Model: Model C – P1		Date: 2-Oct-03	No.: MG094001
Modified Article: Rubber Foot		Prepared by: T. Shintani	
From: 1st Technical Support Sec. Service Support Dept.			
Reason for Modification:	<input type="checkbox"/> Parts catalog correction <input type="checkbox"/> To facilitate assembly <input type="checkbox"/> Part standardization	<input type="checkbox"/> Vendor change <input type="checkbox"/> To improve reliability <input checked="" type="checkbox"/> Other	<input type="checkbox"/> To meet standards (       )
Modification Schedule:	After the old parts have become out of stock.

Model: Model C-P1	Date: 17-Nov-03	No.: MG094002a
-------------------	-----------------	----------------

## MB Correction

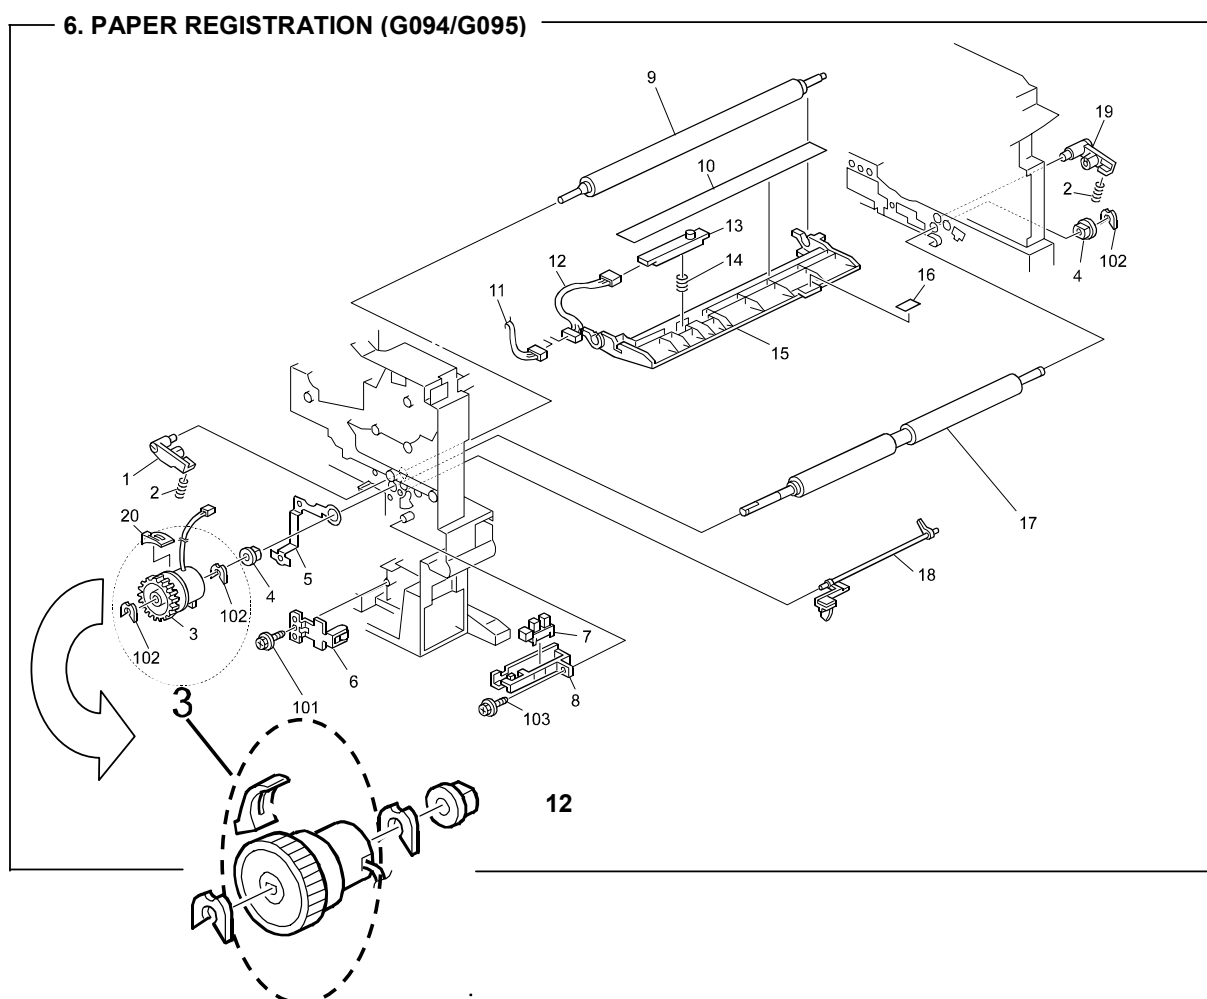
Incorrect Part Number	Correct Part Number	Description	Q'ty	Int	Page	Index	Note
AX200208		Magnetic Clutch – Z45	1→0	- / -	<b>13</b>	3	*
G0763321		Clutch Sleeve Cover	1→0	- / -	<b>13</b>	20	*
	► G0763205	Magnetic Clutch : Registration : Ass'y	0→1	- / -	<b>13</b>	3	*

**Note:** The illustration for the magnetic clutch assembly has been corrected as follows:

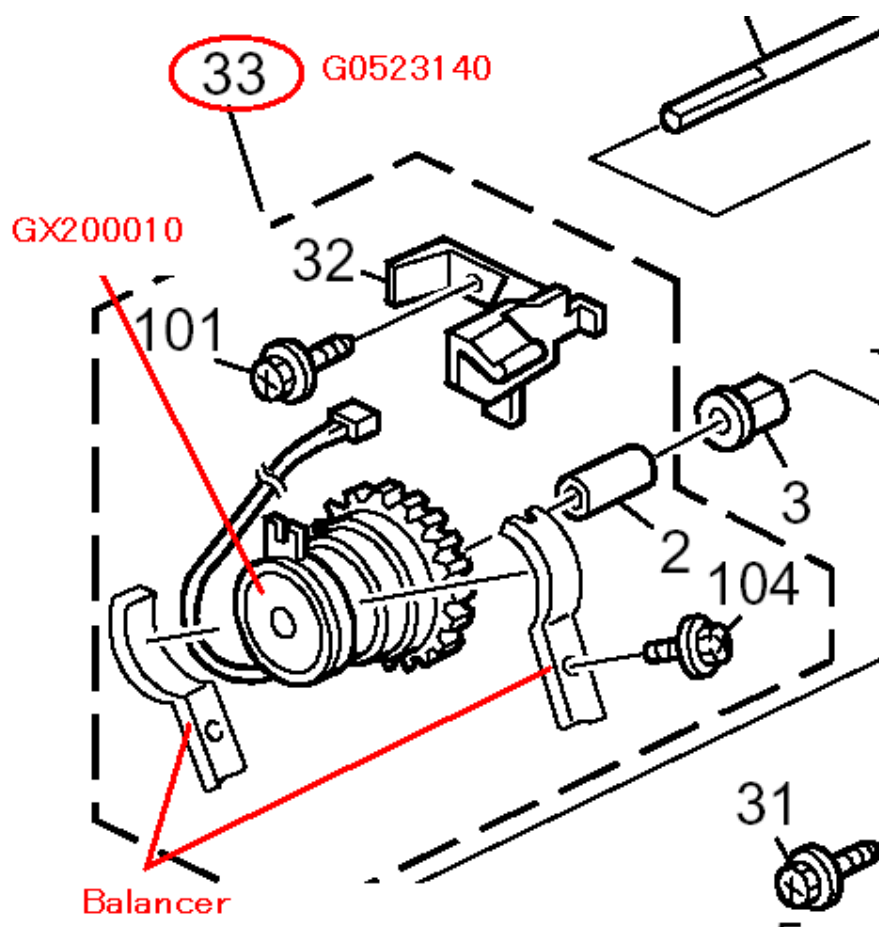
Old Part Number	New Part Number	Description	Q'ty	Int	Page	Index	Note
GZ000003	G1025502	Power Cord – 230V	1→1	O/O	25	9

**Change/Reason:** Parts standardization with the next model (Model C-P2).

**Note:** This applies only to the EU models (230V).

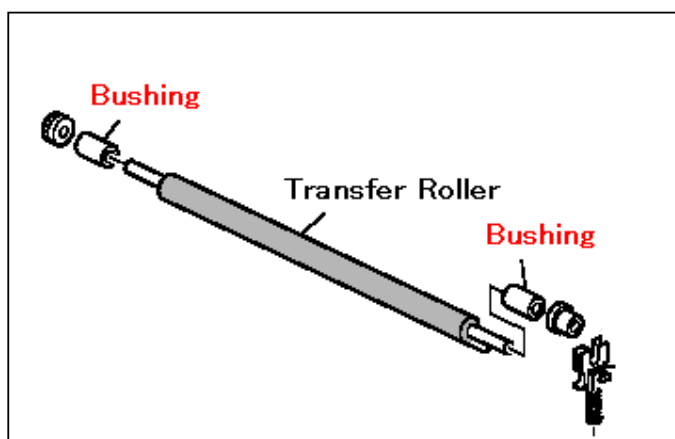
Old Part Number	New Part Number	Description	Q'ty	Int	Page	Index	Note
G0963610	G1296260	Transfer Roller Ass'y	1→1	X/O	15	12	
G0963616	G1296257	Transfer Roller	1→1	X/O	15	14	
G0523618	G1296251	Positioning Roller - Transfer	1→1	X/O	15	15	
G0763619	G1296252	Gear – Transfer Roller	1→1	X/O	15	13	
	G1296255	Bushing	0→2	-	15	25

**Change/Reason:** Parts standardization with the next model (Model C-P2).

**Important:** *All of the new parts in the table must be installed together as a set. You cannot install the new parts individually.*

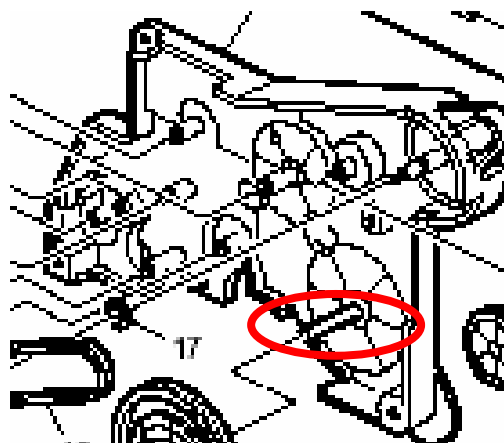
Old Part Number	New Part Number	Description	Q'ty	Int	Page	Index	Note
G0521102	M0011122	Drive Unit Bracket	1→1		23	2

**Change:** The material of the shaft was changed.

**Reason:** To further improve the performance of the drum drive mechanism.
